Re: Dominion Ridge Park

POADP # 711

The City Staff Development Review Committee has reviewed Dominion Ridge Park Subdivision Master Development Plan M.D.P. (formally POADP) # 711. Please find enclosed a signed copy for your files. Your plan was accepted however please note the following:

P.O.A.D.P. REVIEW

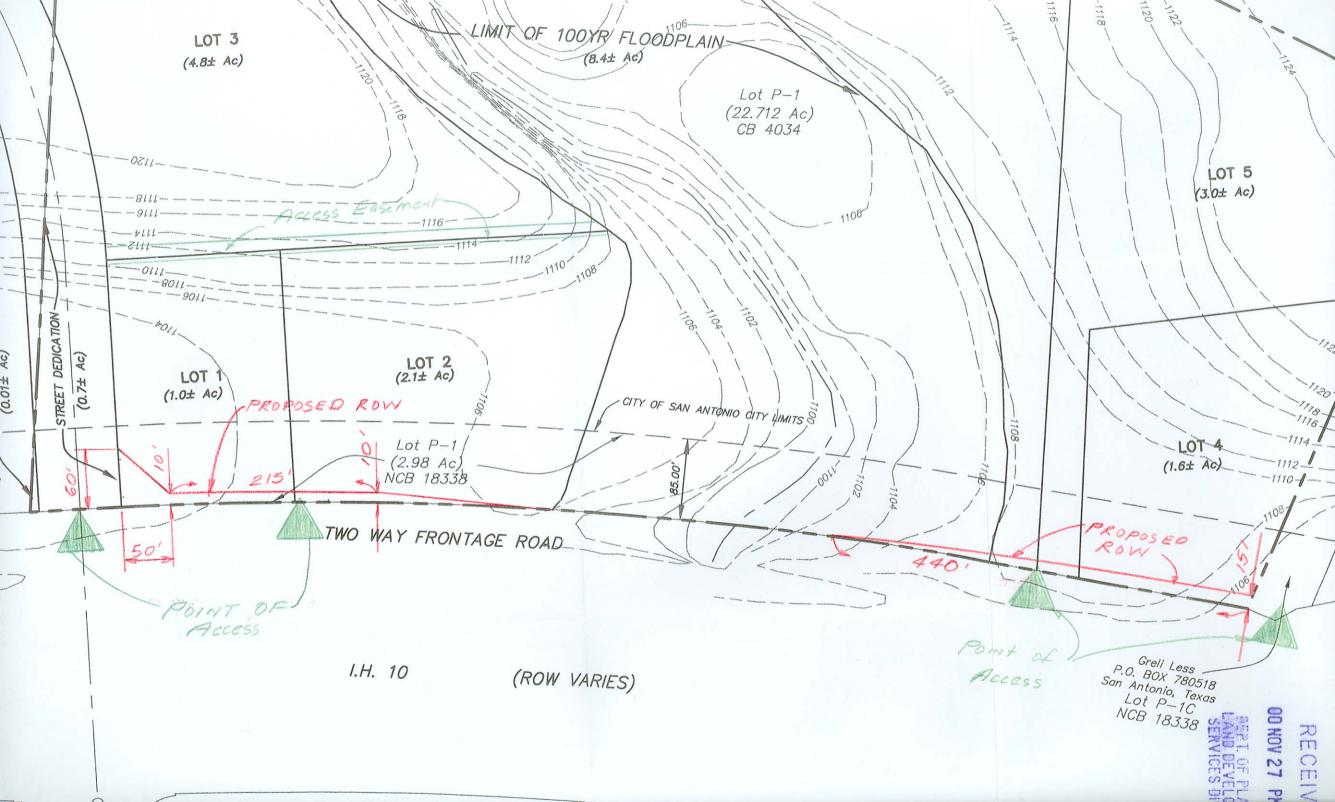
P.O.A.D.P. Reviewed for:	Comments
Noise Mitigation	For residential development directly adjacent to State ROW, the developer shall be responsible for adequate set-back and/or sound abatement.
R.O.W. Requirements	A variable width right of way dedication will be required at the time of platting (see attached layout for approximate dimensions).
Access Limits/Restrictions	Locations and number of access points will be as directed by "Regulations For Access Driveways to State Highways". This property is eligible for a maximum combined total of four access points, as depicted on the attached layout. The four eligible access points include the future extension of Dominion Drive and the existing road identified as "Lot P-1C NCB 18338".
WPAP Requirements	None.
